Baldwin County Planning Commission Staff Report

Case No. SV25-20
Resub Lot 1 Lillian Acres - Variance for 30ft flag lot
Case No. SC25-44
Resub of Lot 1 of Lillian Acres
November 6th 2025

SC25-44
Resub of Lot 1 of Lillian Acres
Plat Map

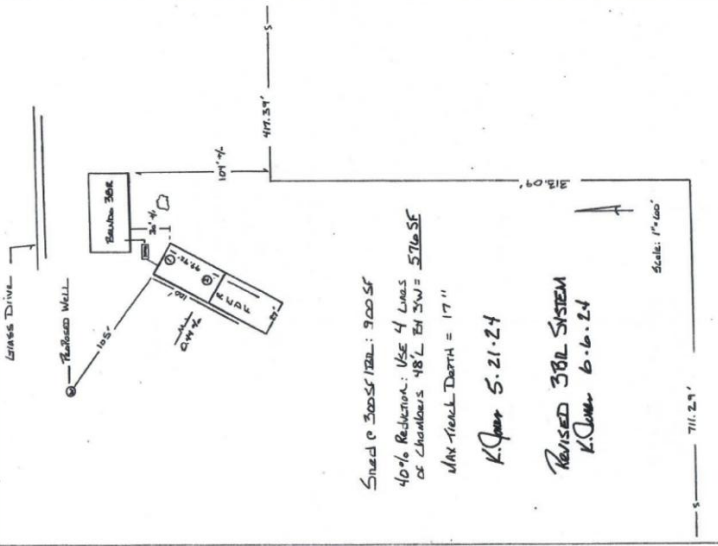
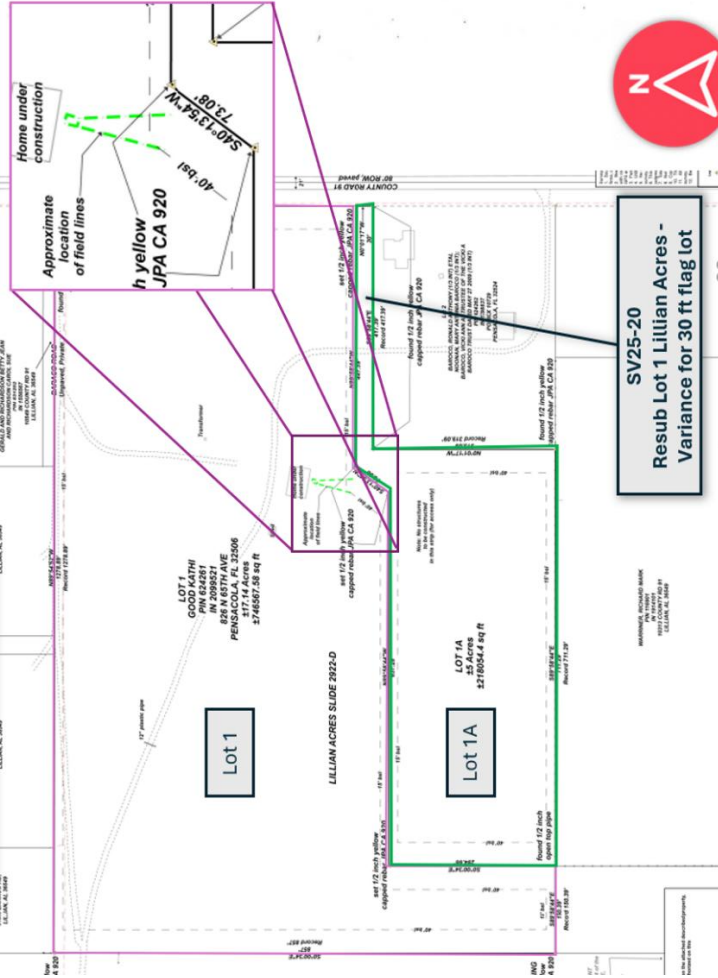
Permit Engineer, Josh Newman: The applicant asked for relief from the 60' wide flag requirement. The hardship (the location of the septic field lines) does not appear to meet the requirements of a valid hardship since this is self-imposed according to section 8.2.2 of the subdivision regulations and the location of the new field lines shown on the plat does not appear to be accurate either when compared to the health department map.
